Project	IEEE 802.16 Broadband Wireless Access Working Group < http://ieee802.org/16 >	
Title	Problems with DBPC Messages and a Solution	
Date Submitted	2005-03-16	
Source(s)	David A Castelow, Gavin Meakes, Eyal Verbin Airspan Communications, Cambridge House, Oxford Road, Uxbridge, UK	Voice: +44 1895 467281 Fax: +44 1895 467202 mailto:dcastelow@airspan.com
	Chi-Chen Lee, Tzu-Ming Lin, Yu-Ren Yang, Chia-Feng Kang CCL, ITRI, Bldg. 11, 195 Sec. 4, Chung Hsing Rd. Chutung, HsinChu, Taiwan 310, R.O.C.	mailto:jjlee@itri.org.tw
	Rainer Ullmann, Donald Stevenson Wavesat Inc, 1375 Trans-Canada Highway Suite 300 Dorval, Quebec H9P 2W8, Canada	mailto:rullmann@wavesat.com
	Radu Selea Redline Communications	mailto:Radu@redlinecommunications.com
Re:	Document to support comment to Letter Ballot #17	
Abstract	Changes required to prevent DBPC message flooding of 802.16 systems	
Purpose	The document is intended for consideration in comment resolution process of LB #17.

Problems with DBPC Messages and a Solution

Figure 1

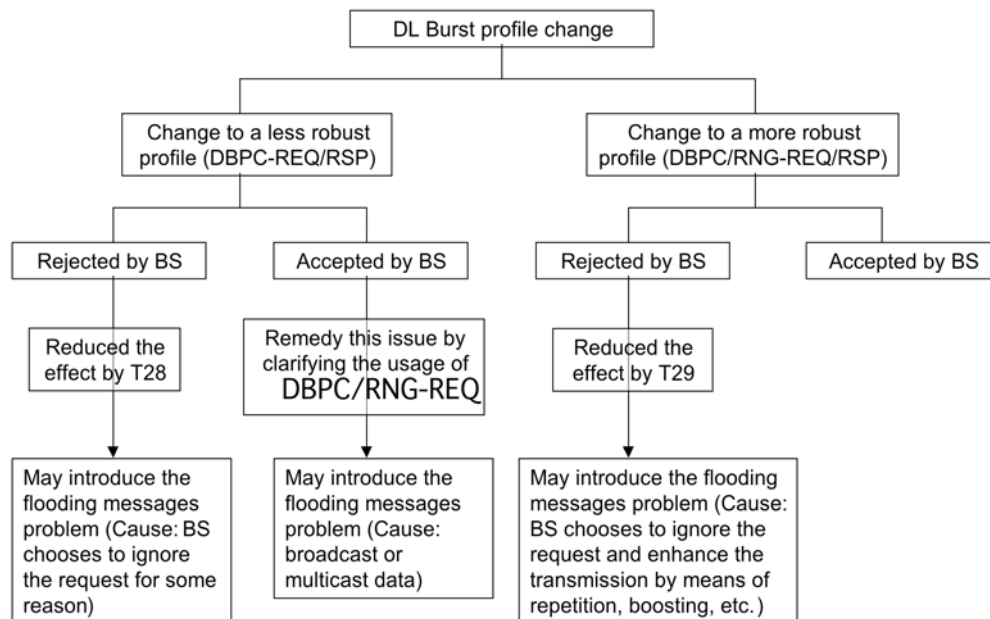
Figure 1 summarizes the scenarios of the flooding problem, and the suggested remedies (T28/T29).

Figure 80—Transition to a less robust operational burst profile

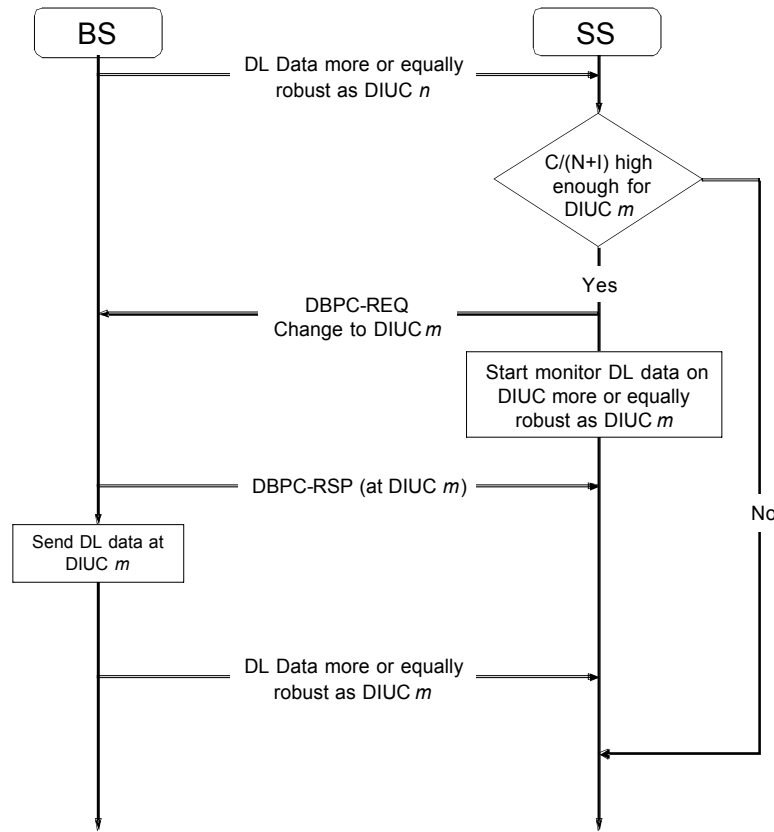
Page 201: Figure 80 needs to indicate action of SS in the event of the BS refusing the DBPC-REQ to move to a less robust modulation. State transition diagrams are needed here, so rather than complicate these diagrams, we introduce a separate figure. This diagram requires timers, so that the BS is not flooded with requests. The diagram (Figure 80a) indicates the actions for the SS, and includes new timers (T28, T29, and T30).

Also DL data may be on DIUC up to m, not at m. This requires a change to Figure 79, too. RNG-REQ only to be used for transition to more robust cases (see 6.3.10.1).

This requires a change to Figure 80. This leads to the following text changes in [4]:

Change Figure 79 as indicated:

Figure 80a – State transition diagram for downlink burst profile management – SS

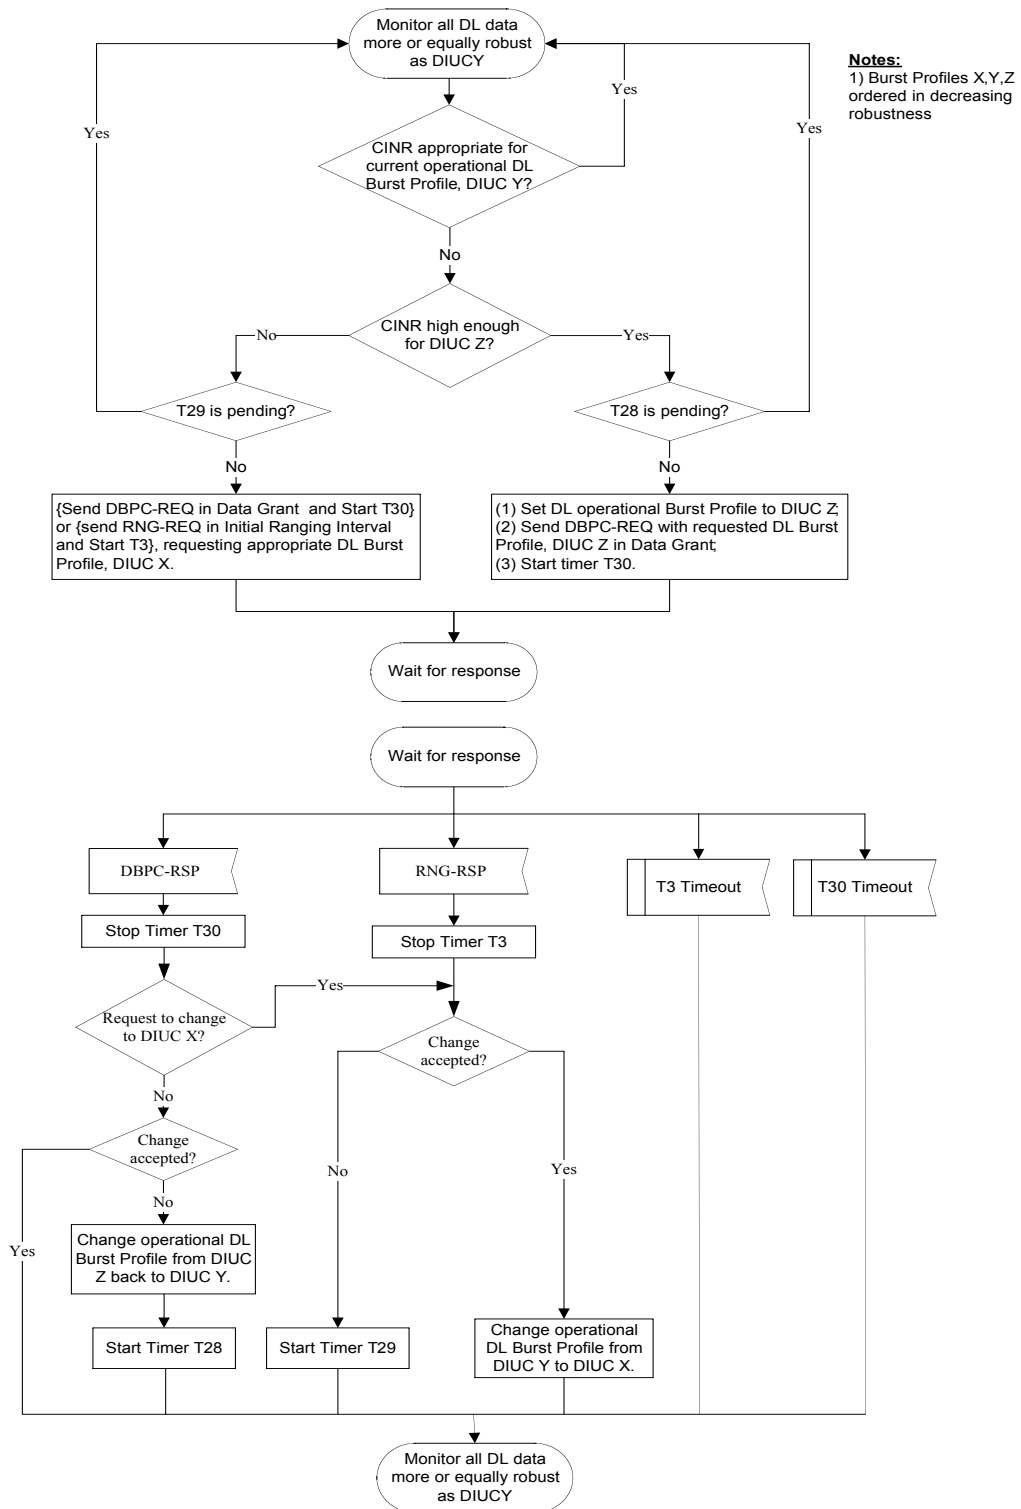
Insert new Figure 80a (see end of contribution).

System	Name	Time reference	Minimum value	Default value	Maximum value
SS	T28	DBPC-REQ re-try timer for requesting less robust burst profile after rejection by the BS.	200 ms	1 s	1 min
SS	T29	RNG-REQ/DBPC-REQ re-try timer for requesting more robust burst profile after rejecting by the BS.	200 ms	1s	30s
SS	T30	DBPC-RSP reception timeout following the transmission of a DBPC-REQ.	200 ms	200 ms	200 ms
